MEMORANDUM

TO: District of Columbia Board of Zoning Adjustment
FROM: Maxine Brown-Roberts, Project Manager
JL Joel Lawson, Associate Director Development Review
DATE: July 12, 2018
SUBJECT: BZA Case 20074 - Special Exception review to allow construction of an apartment building at 2604 & 2610 Stanton Road, SE.

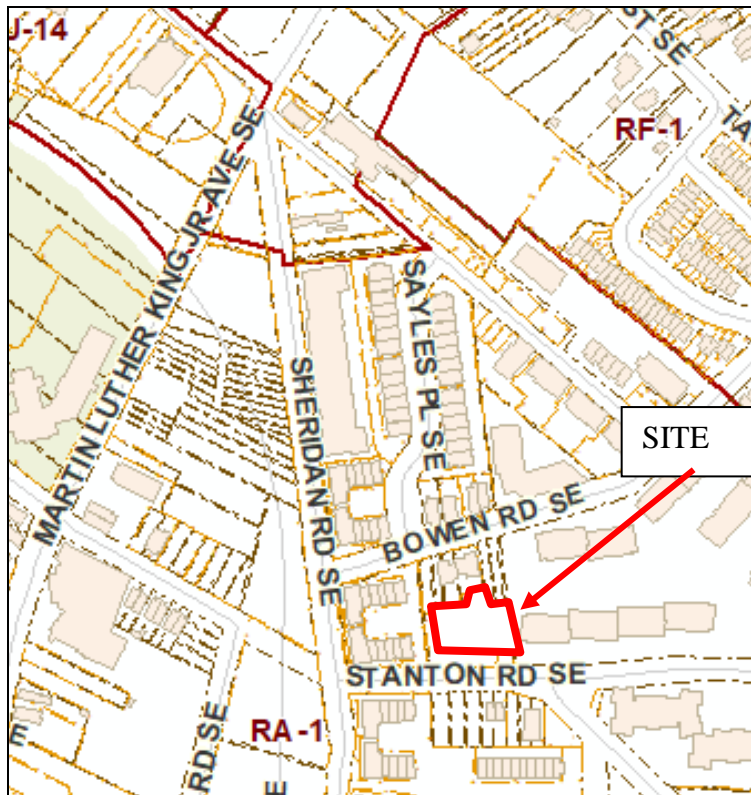
With regards to the parking lot landscaping relief, the applicant has not made a compelling case for this relief, which, with minimal changes, would appear to be able to be met. While OP is not opposed to the applicant providing more than the required number of parking spaces, this should not be at the expense of other zoning provisions intended to minimize the visual, environmental, and potential stormwater runoff impacts on the neighborhood. Instead, OP feels that the applicant should meet the landscape area and trees and shrub requirements, which would appear to result in one fewer parking spaces (14 spaces instead of 15, where 3 spaces are required).

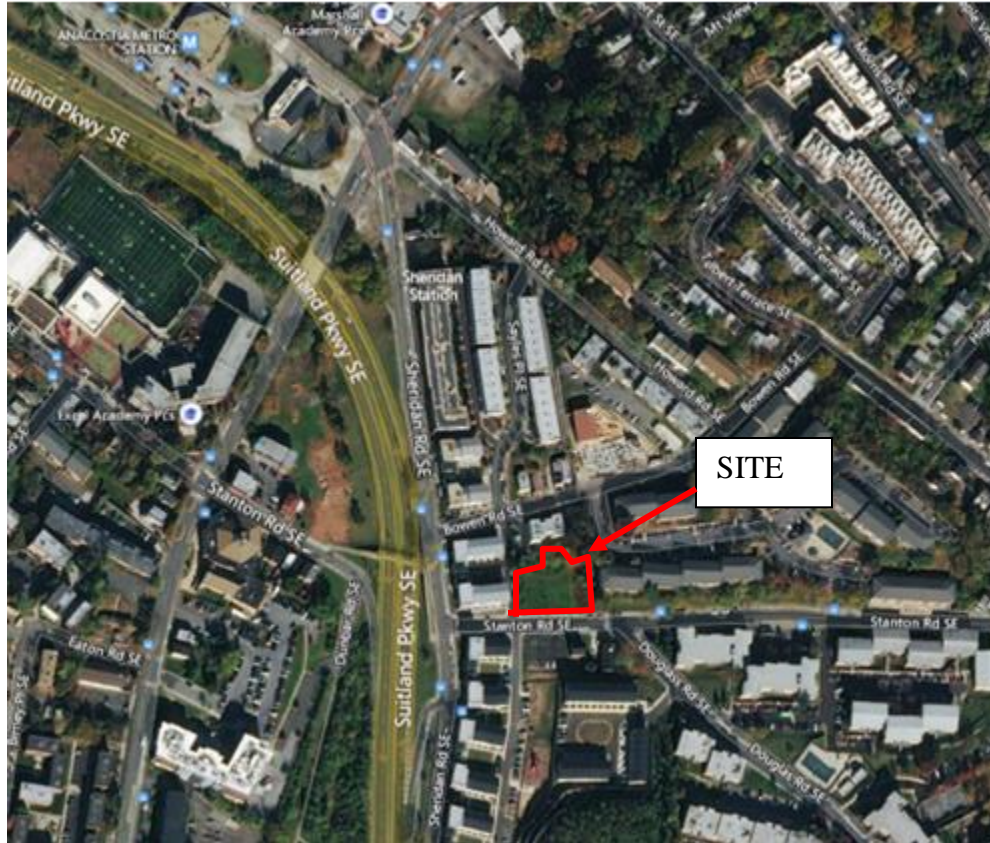
While detailed landscape plans were not provided, the drawings may also indicate that retaining walls, to accommodate the parking lot, may also require relief (special exception relief from C § 1401 pursuant to C § 1402.1). OP requested that the applicant look into this, but the applicant has not made such a request as of the date of this report, so OP has not provided analysis.
